Access Compliance Report

Public Rights-of-Way

(Curb Ramps)

Intersection ID: N/A	Main Street: NEW_FASHION_WY	Cross Street: N/A	Location: E
ADA ID: 24F0F8C14A6A	Ramp Type: Perp	Initial Pass/Fail: Fail	Overall Compliance: No
Severity Score: 21.25			
Codes/Mitigation Info/Possible Solution		Field Measurements/Component Compliance

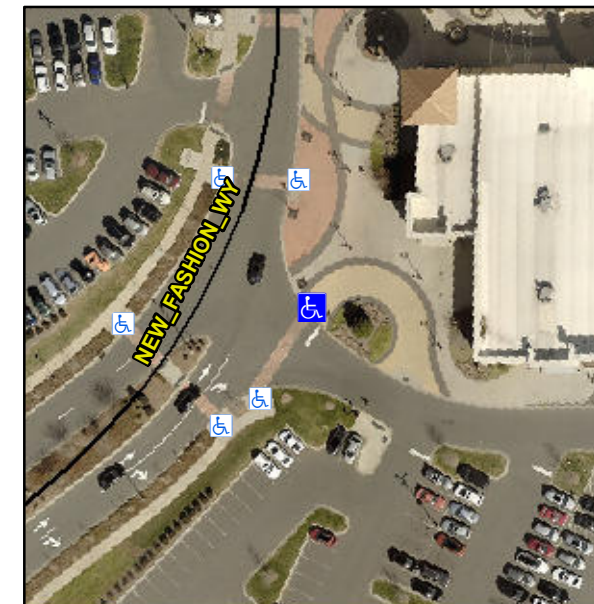
Not Found, R304.5.1, R304.2.2

Compliance	Description	Data	Compliance	Description	Data
N/A	Ramp Length (in)	61.0	No	Ramp Slope (%)	8.6
No	Ramp Width (in)	46.0	Yes	Ramp XSlope (%)	0.1
N/A	Flare Type LT	N/A	N/A	Flare Type RT	N/A
N/A	Flare Slope LT (%)	N/A	N/A	Flare Slope RT (%)	N/A
N/A	Flare Traversable LT?	N/A	N/A	Flare Traversable RT?	N/A
N/A	Landing Length (in)	N/A	N/A	DWS Provided?	N/A
N/A	Landing Width (in)	N/A	N/A	DWS Contrast?	N/A
N/A	Landing Slope (%)	N/A	N/A	DWS Length (in)	N/A
N/A	Landing X Slope (%)	N/A	N/A	DWS Full Width?	N/A
N/A	Landing Curb? (Y/N)	N/A	N/A	DWS Offset (in)	N/A
N/A	Shared Landing?	N/A			
N/A	Gutter Ponding?	N/A	N/A	Gutter Slope (%)	N/A
N/A	Gutter Lip Ht (in)	N/A	N/A	Gutter X Slope (%)	N/A
N/A	Painted X Walk1?	Yes	N/A	Painted X Walk2?	N/A
	X Walk 1 Direction	To SW		X Walk 2 Direction	N/A
N/A	X Walk 1 Width (in)	80.0	N/A	X Walk 2 Width (in)	N/A
	X Walk 1 Slope (%)	7.1		X Walk 2 Slope (%)	N/A
	X Walk 1 X Slope (%)	0.7		X Walk 2 X Slope (%)	N/A

Remove & Replace Entire Ramp.
